RFP 2023-07

FLORIDA KEYS MOSQUITO CONTROL DISTRICT

HANGAR ROOF

Questions & Answers

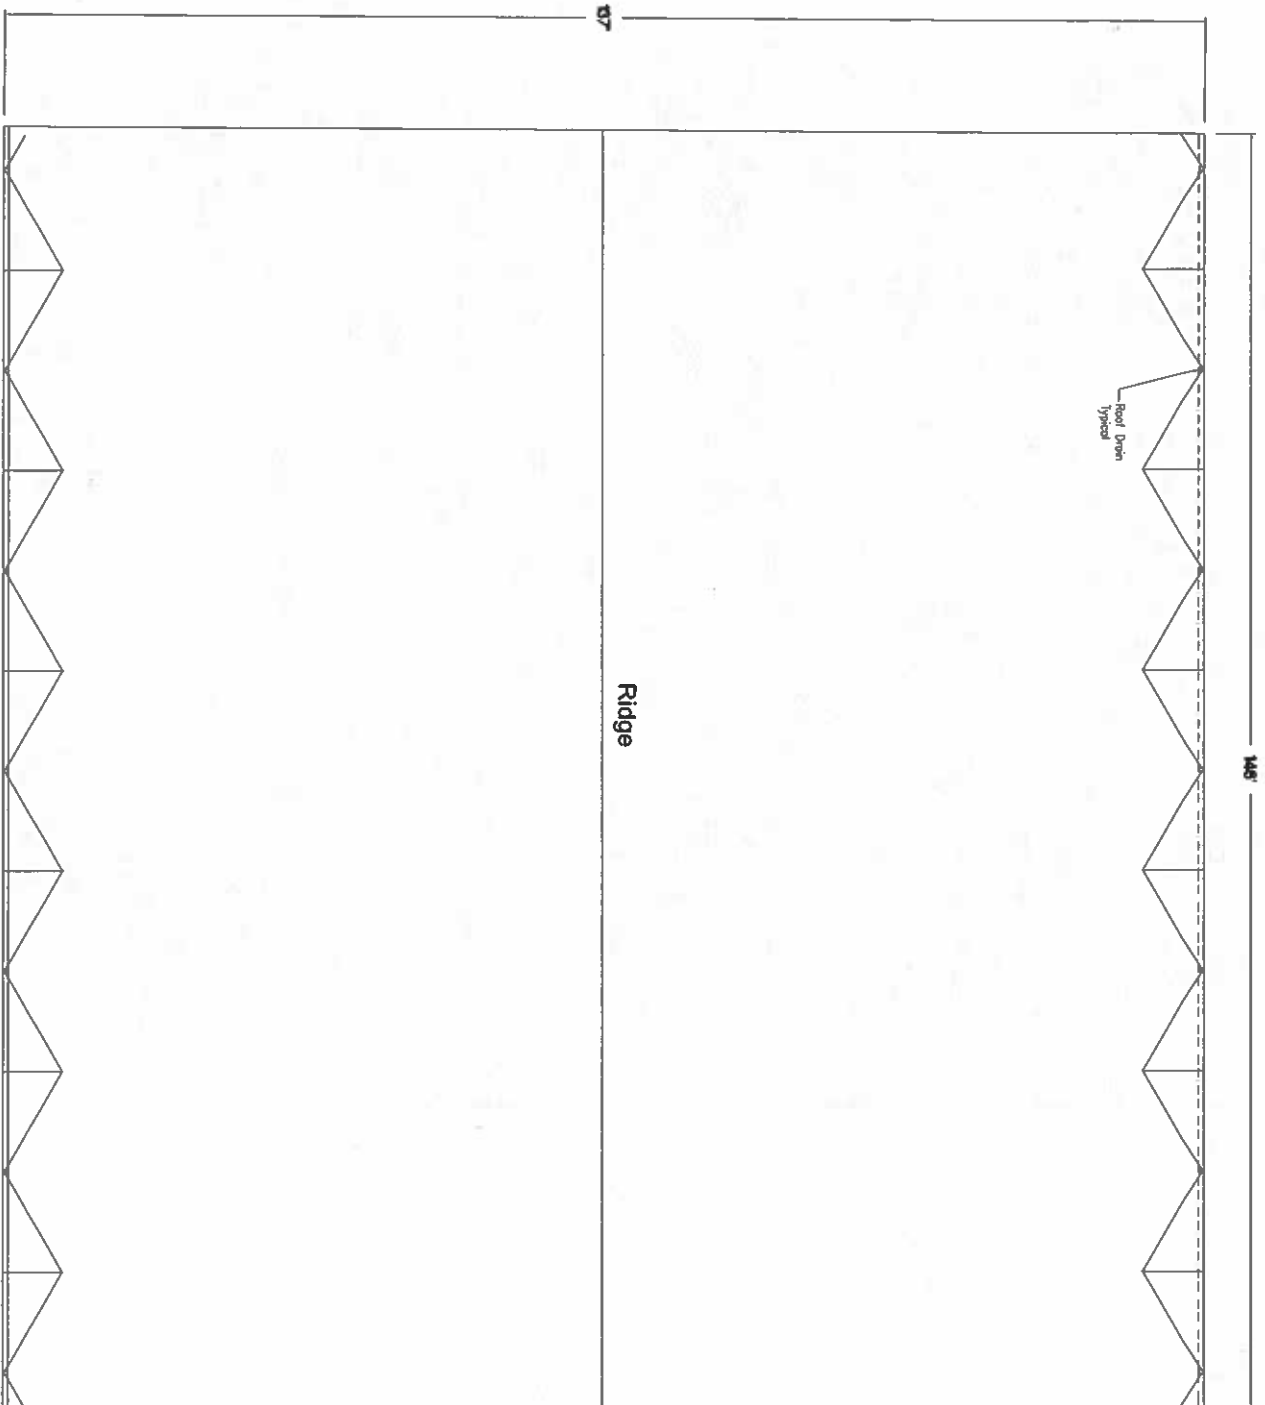
To achieve a full blanket 20-year Manufacturer’s warranty, Acme proposes filling in the gutters and adding roof drains with crickets. Overflow thru-wall supports may be necessary as well. I have attached a detailed drawing to give you an idea of our proposed solution.

Provide proposed change to roof drain system in bid proposal. Manufacture warranty conditions can be addressed in the proposal.

1.6 Detail

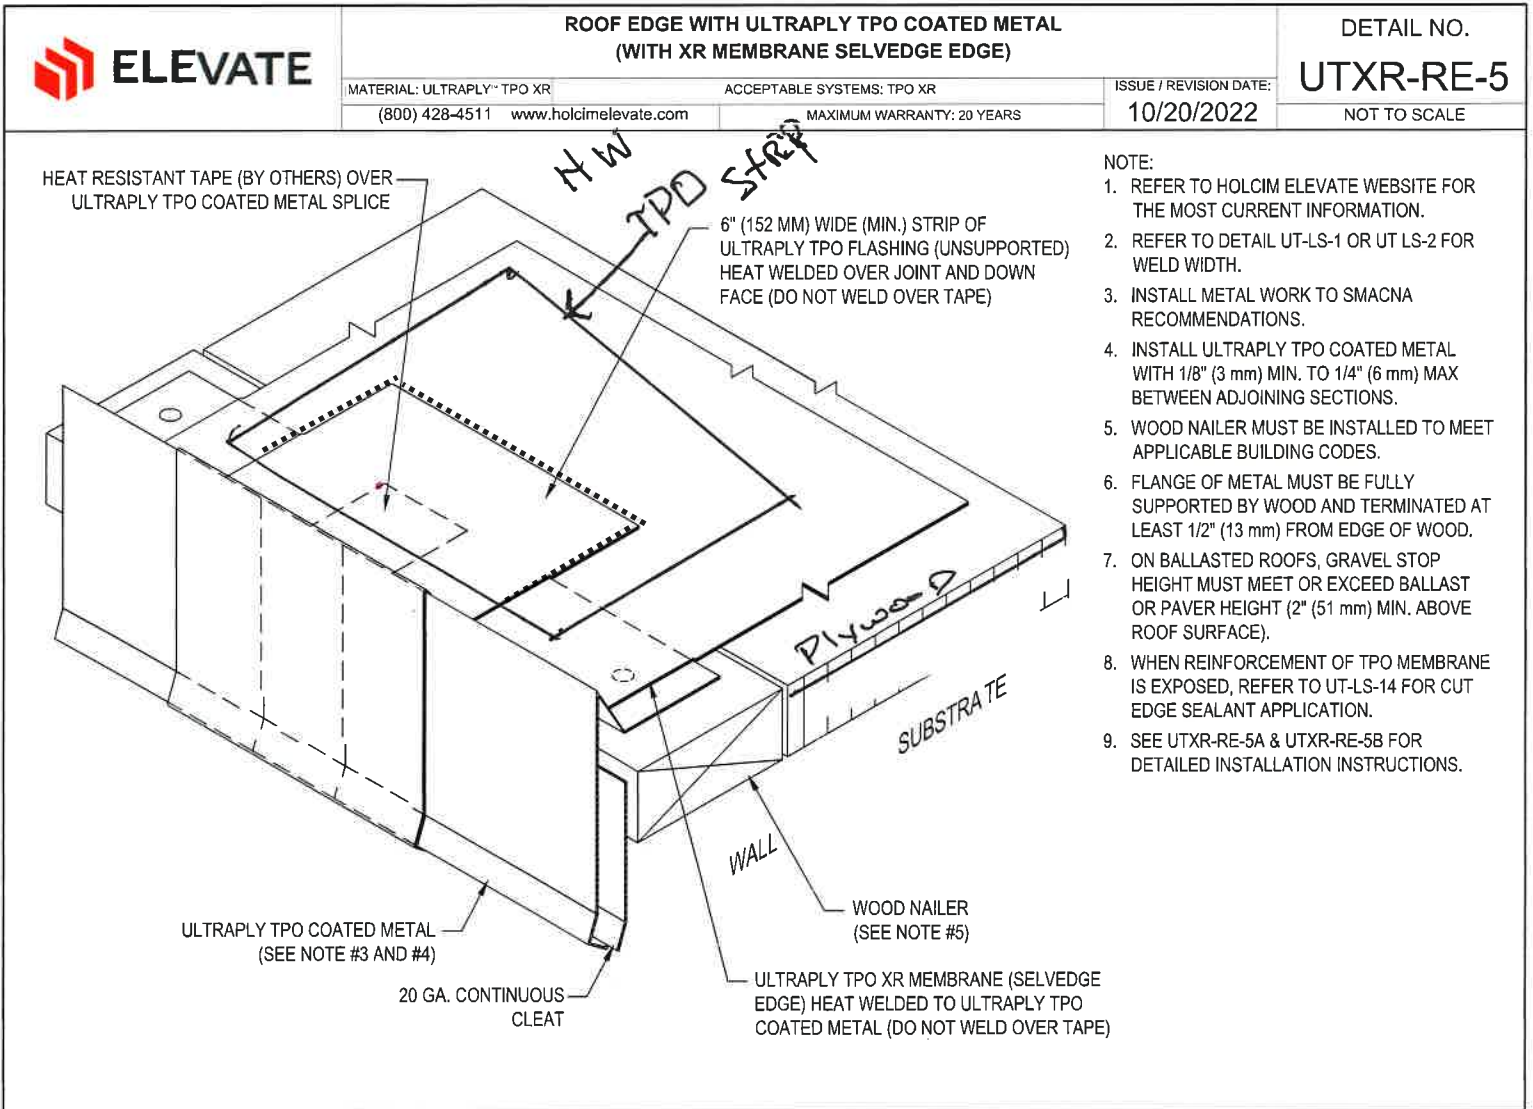
Provide conformation this installation, this will require your edge metals (gravel stop) and trim pieces at gutter edges to be stripped in with "Peel & Stick Quick Seam product!" although acceptable by most manufactures not a recommendation of Key's All Area Roofing. A preferred installation of 24g TPO Clad Metal (white) Edges with TPO strip heat welded to metal edge and extend 4" onto roof membrane with 1-1/2" heat welded seam. The .040 mil prefinished aluminum can be snapped on to face of Clad Metal if still desired. (see attached detail)

1.7 Preferred method of applying terminal edge material is acceptable.
